DRB CASE ACTION LOG - BLUE SHEET

Project #: 100871dp Application #: 11DRB-70212
Project Name: Del Norte Plaza
Agent: Modulus Architects Inc. Phone #:

**CITY OF ALBUQUERQUE
PLANNING DEPARTMENT
December 7, 2011
DRB Comments**

CITY OF ALBUQUERQUE
PLANNING DEPARTMENT
DEVELOPMENT REVIEW BOARD

Design Proposal for:
CHIPOTLE MEXICAN GRILL
Paseo Del Norte

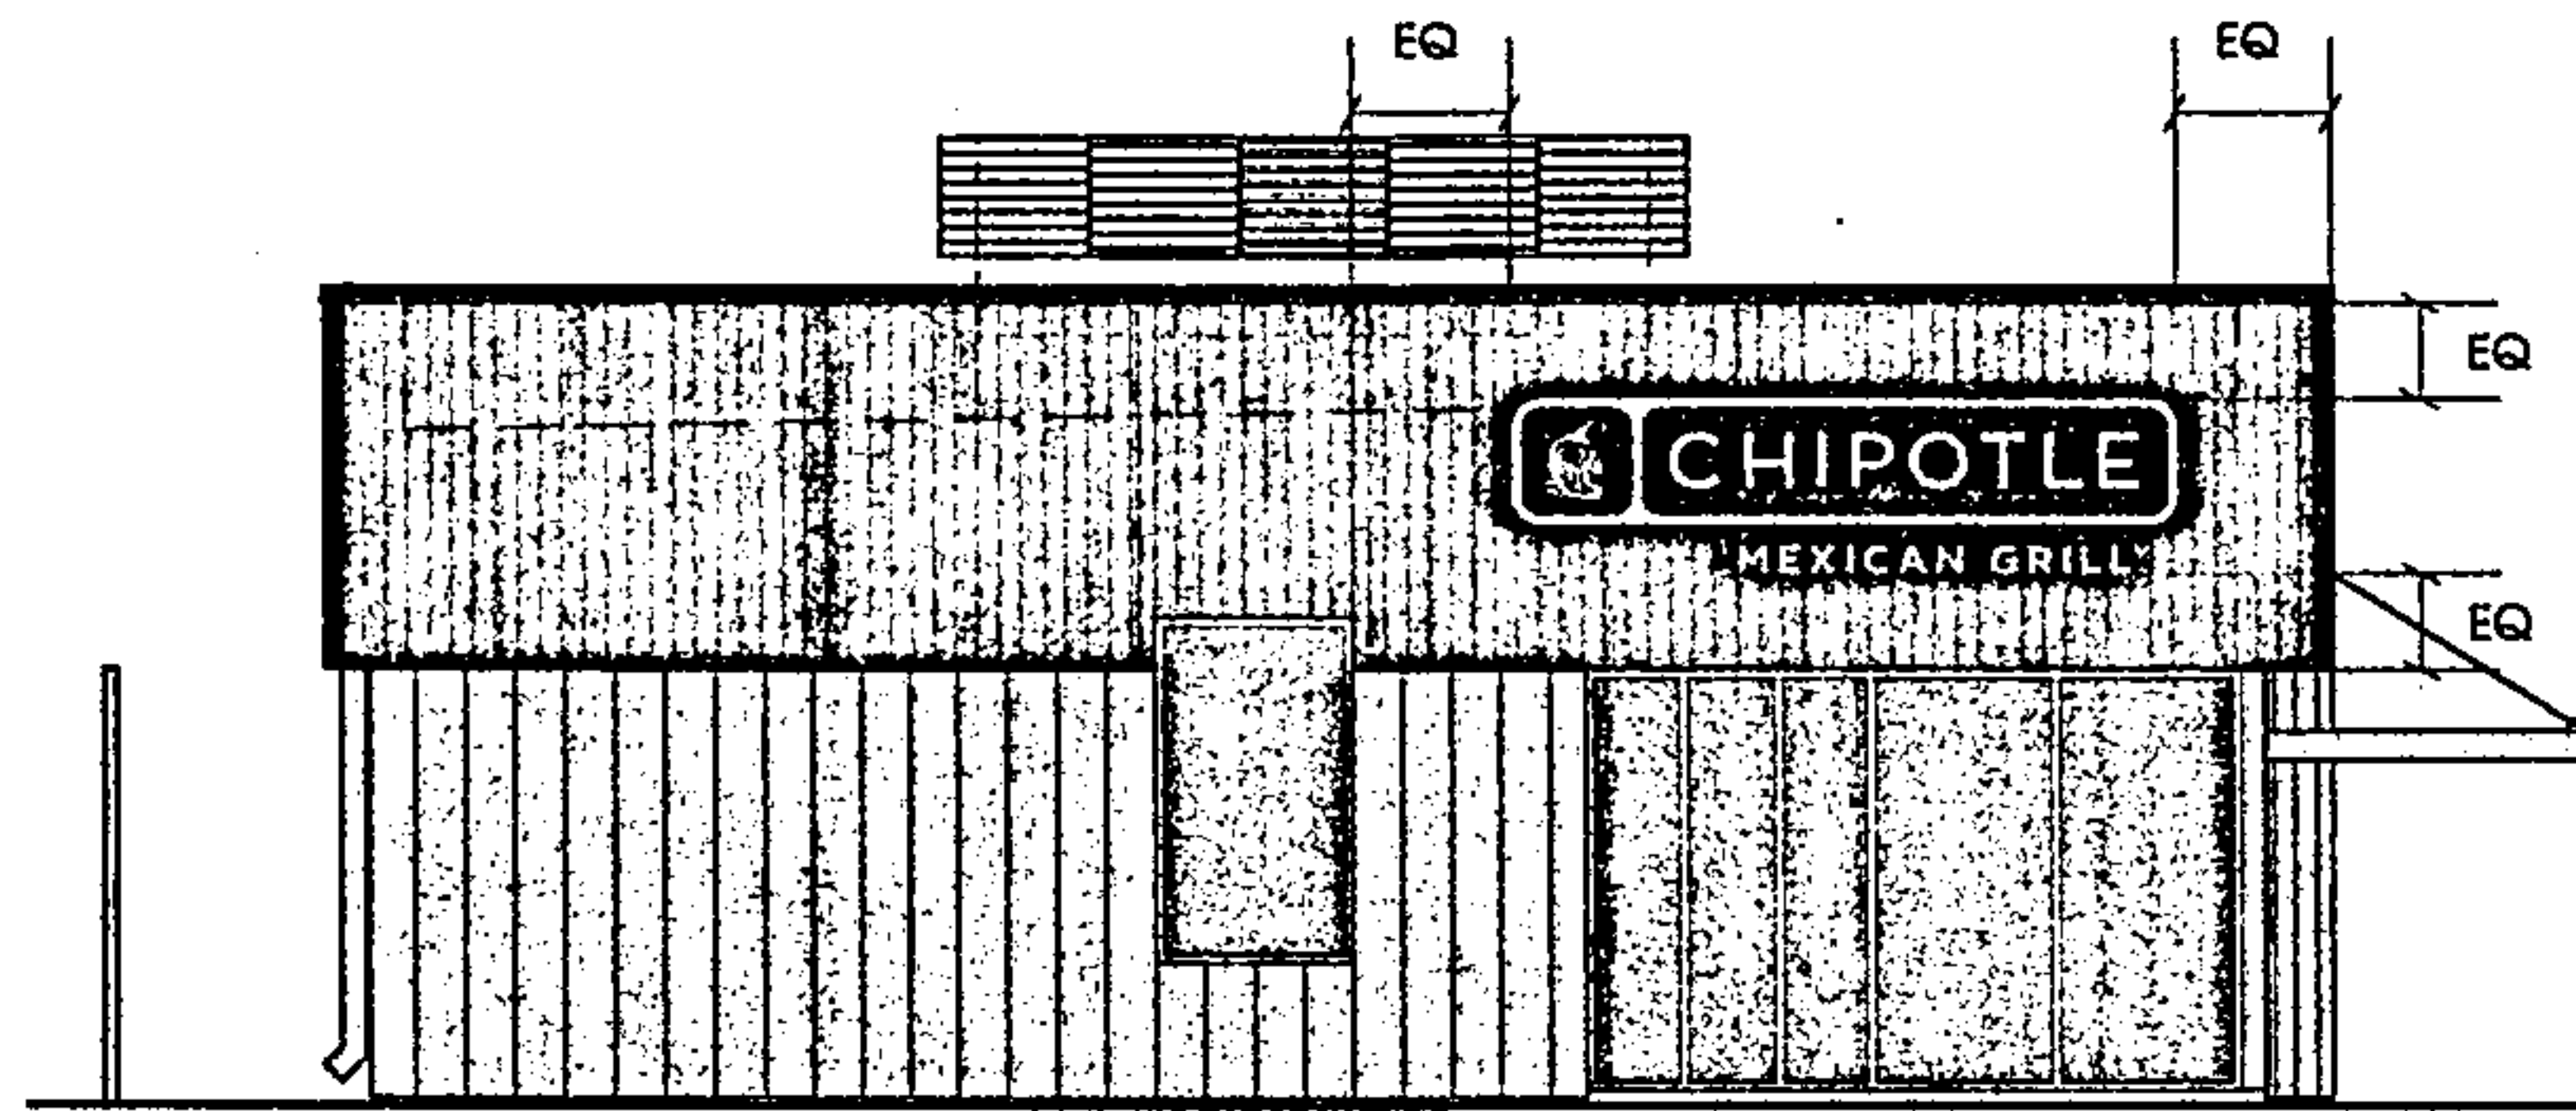
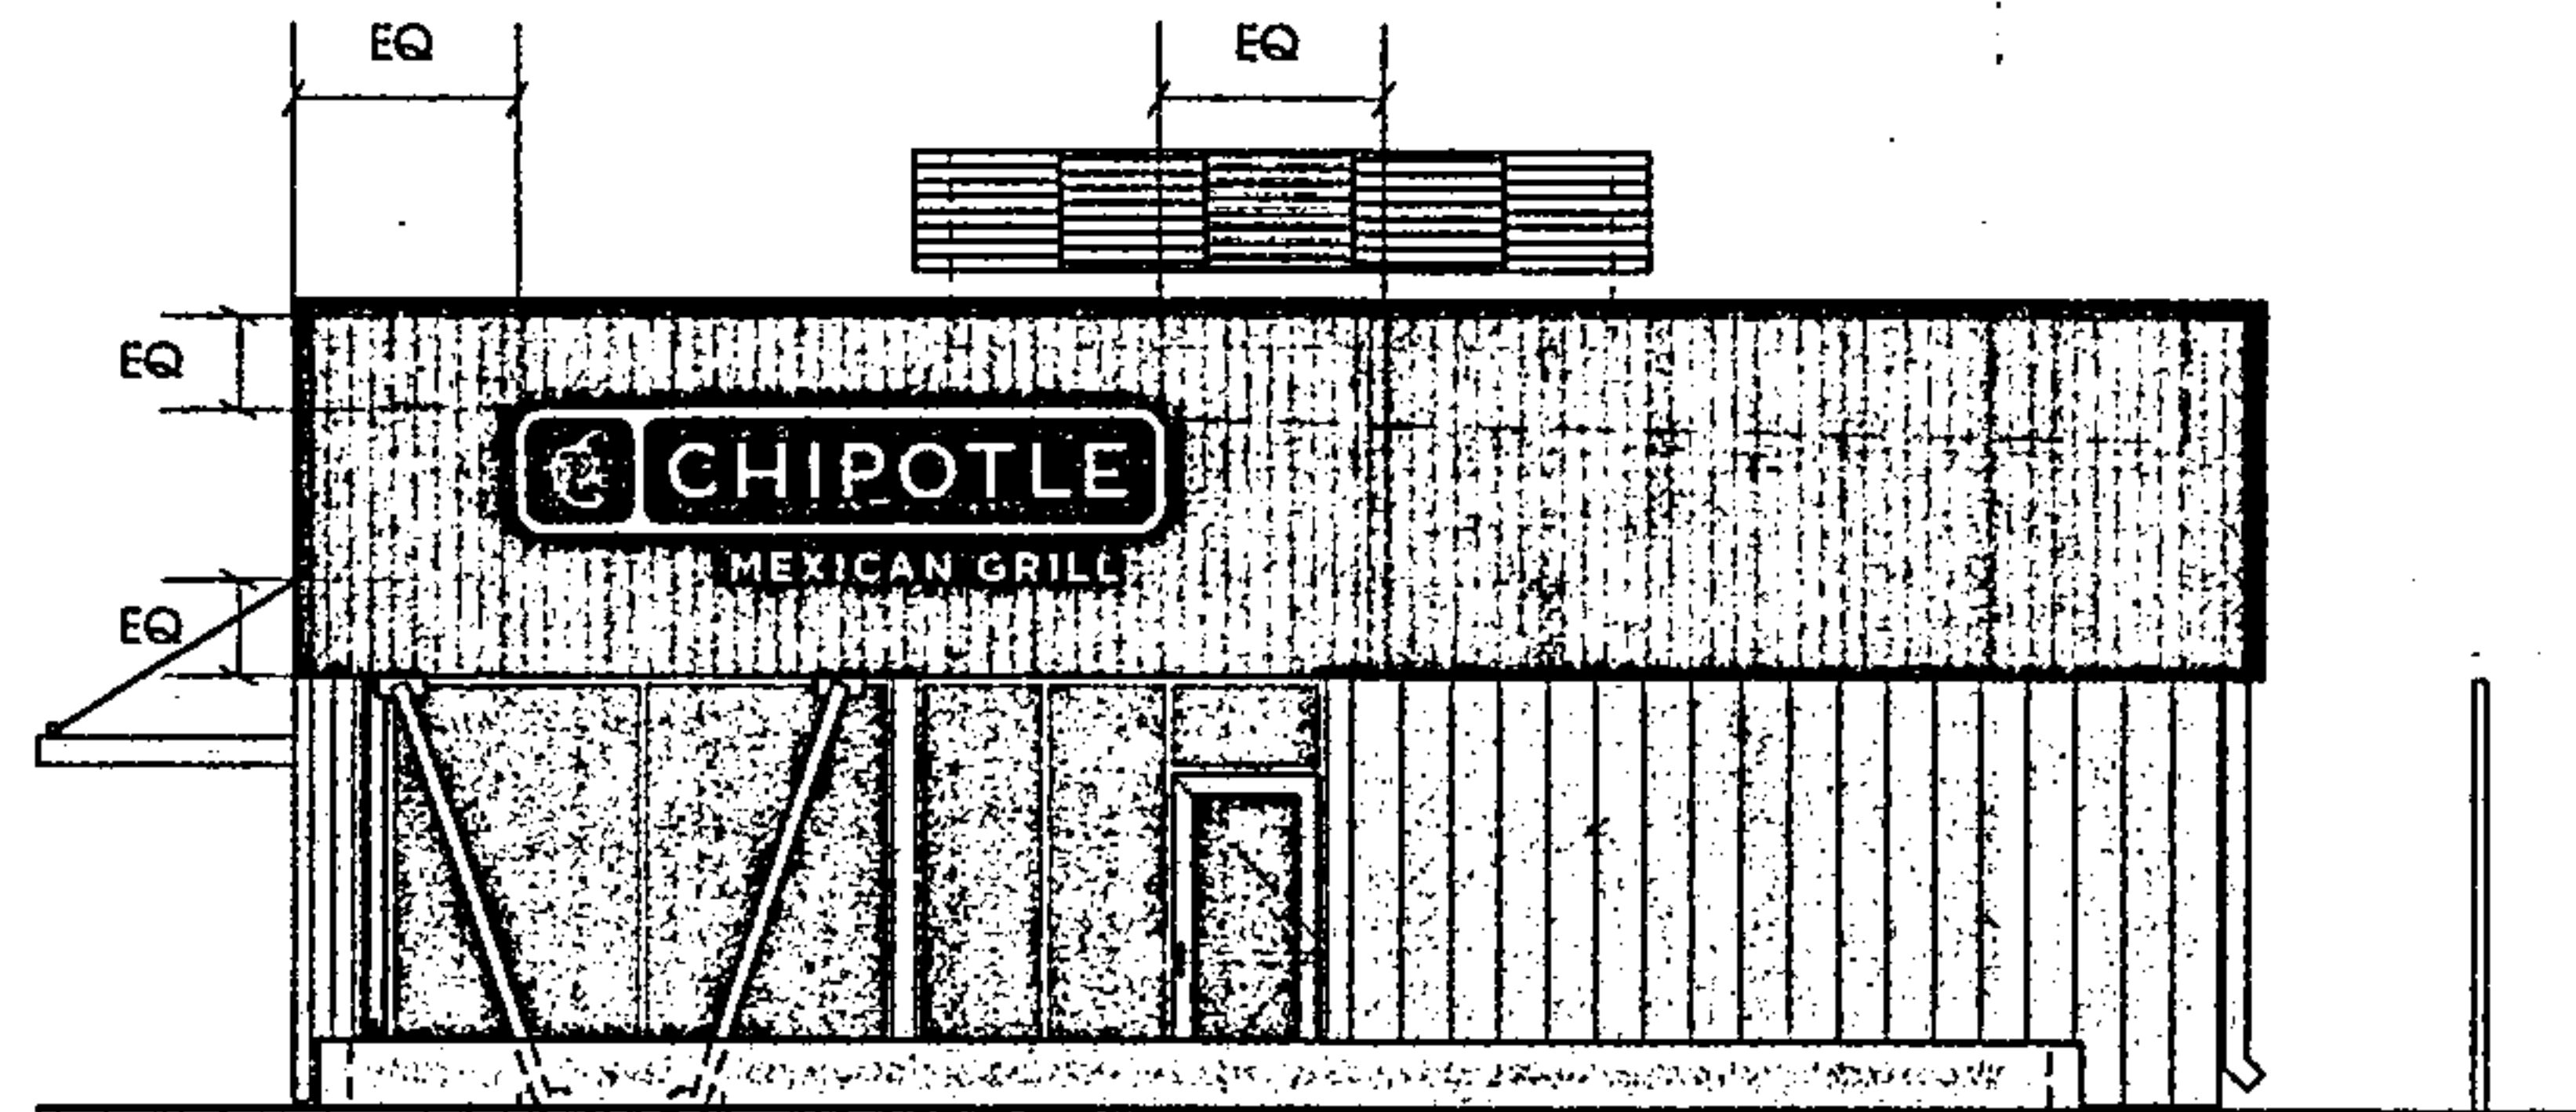
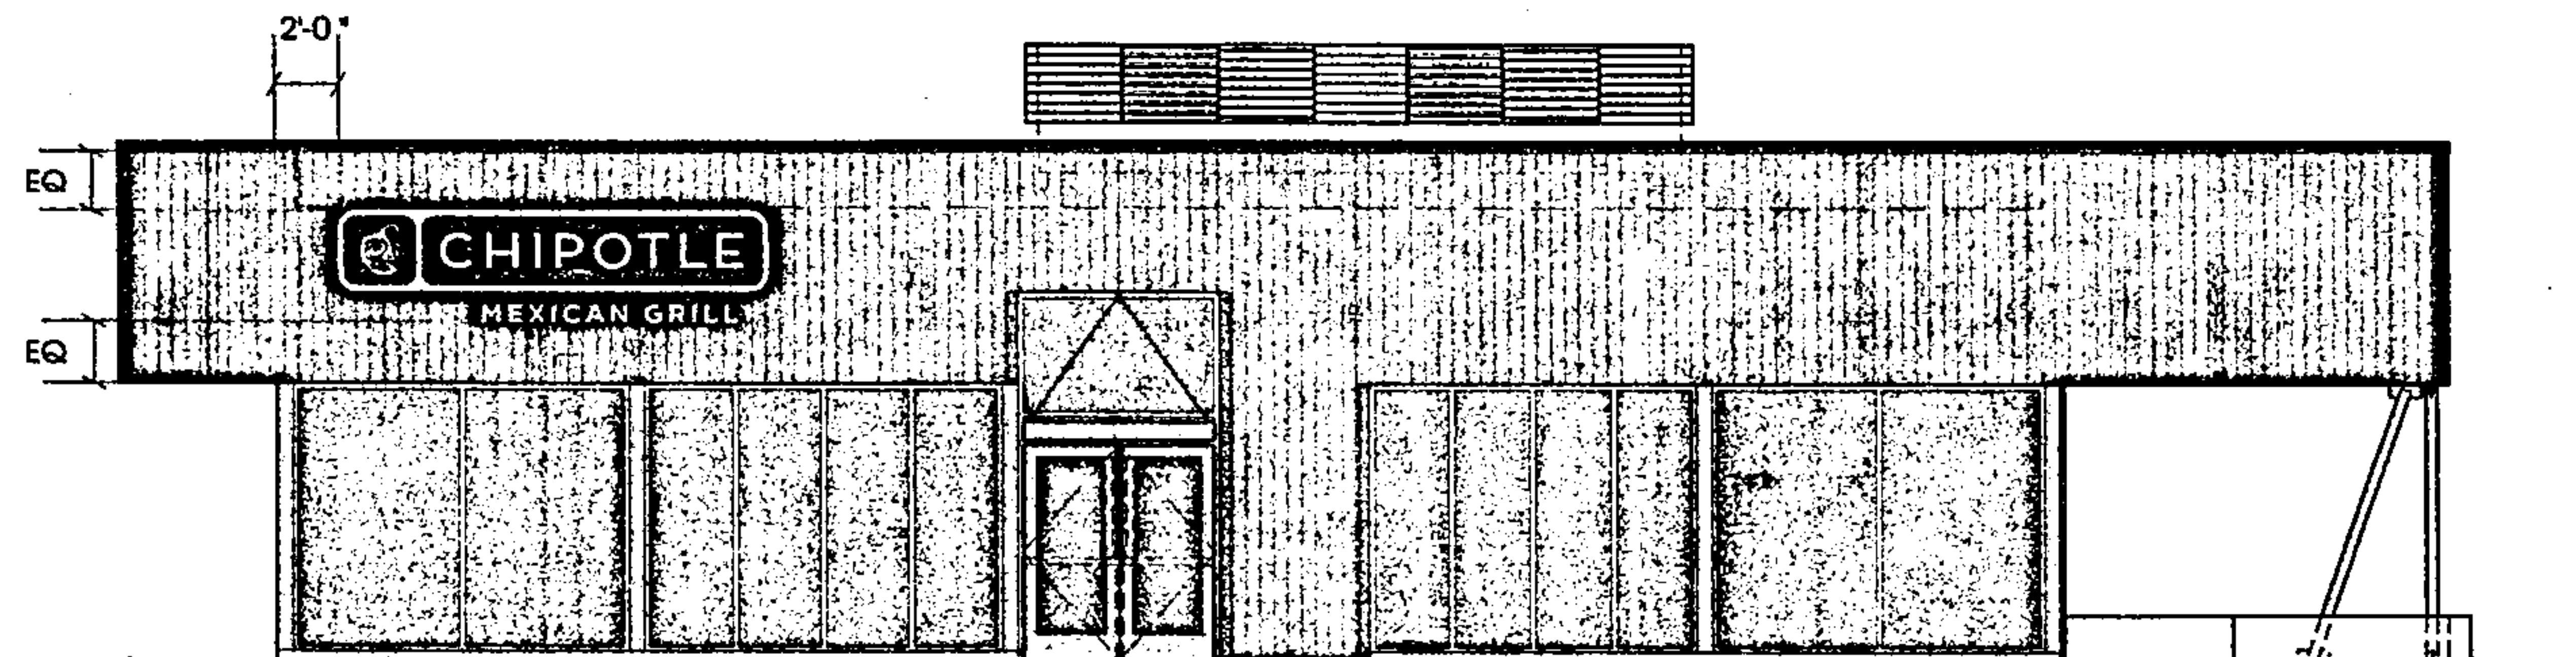
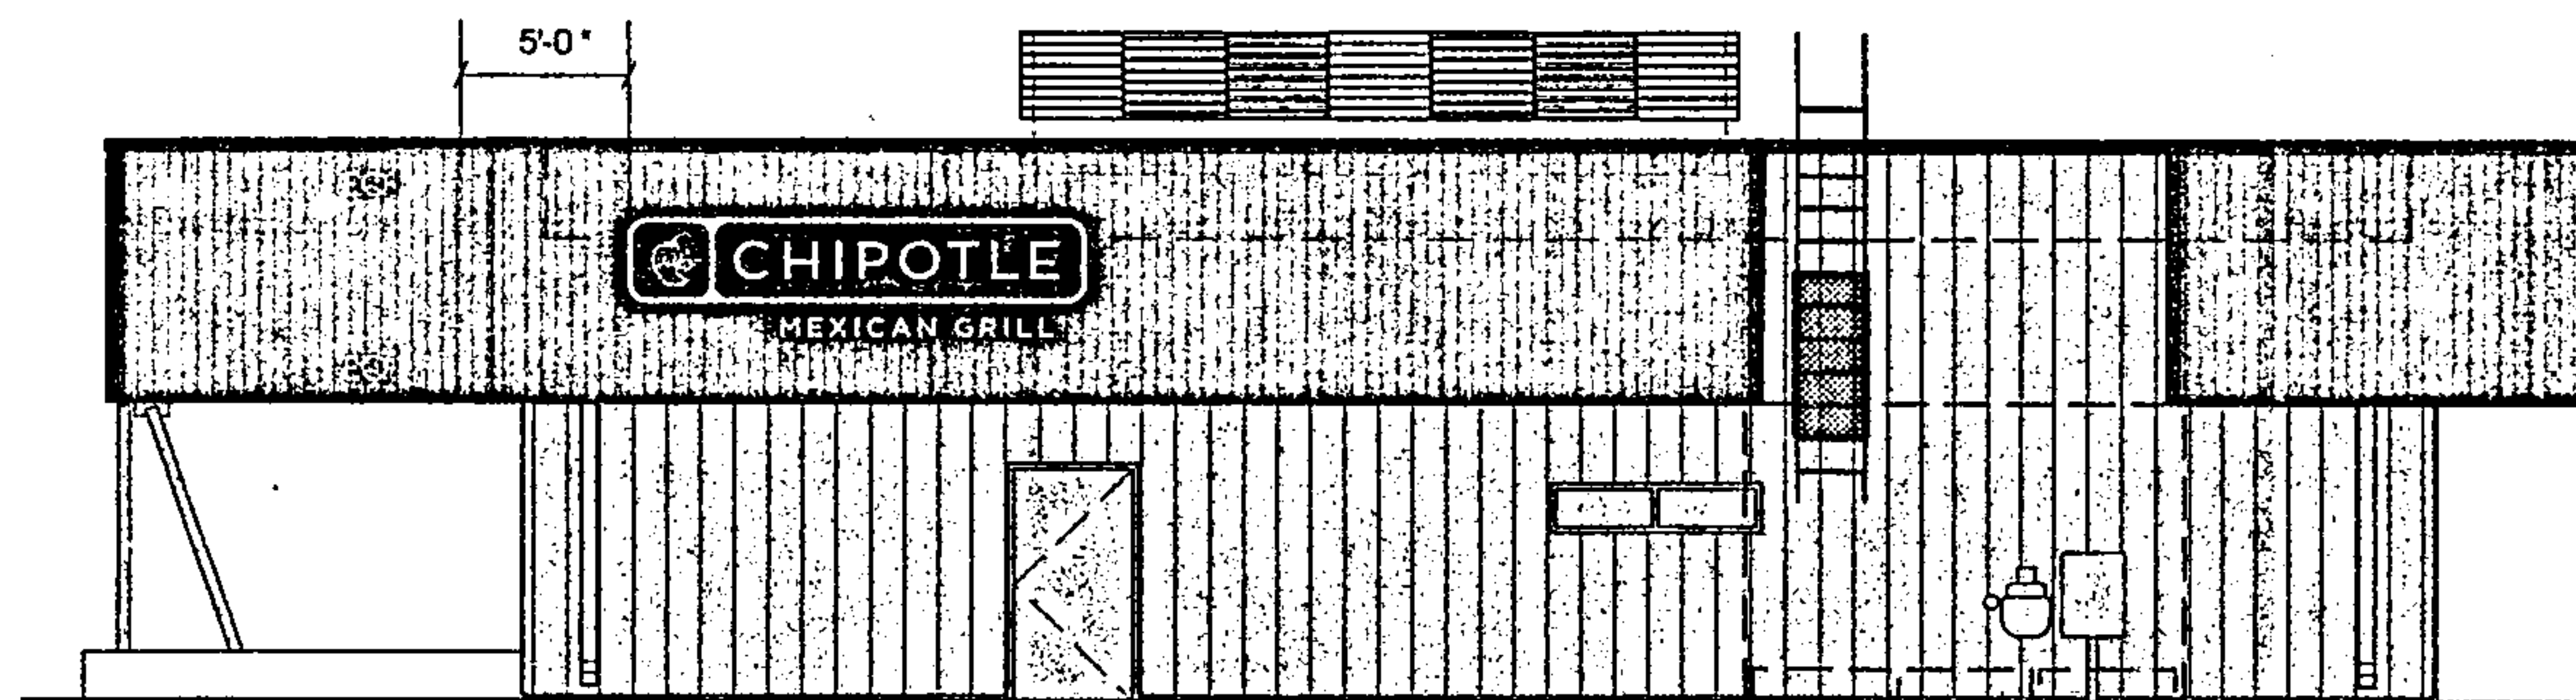
Color elevations are required per the site plan checklist – color photos of the car wash are needed to compare with the proposed Chipotle elevations. Chipotle elevations need to be accurately scaled.

Building design need to present a cohesive visual relationship per the sector plan; refer to brick/stone wainscott with stucco for McDonald's and Chick-fil-A. Building elevations for Chipolte need to note material and color and must be dimensioned; roof mounted equipment must be screened, and only two building mounted signs are permitted. Any building mounted signage for Panda Express must be shown on elevatons.
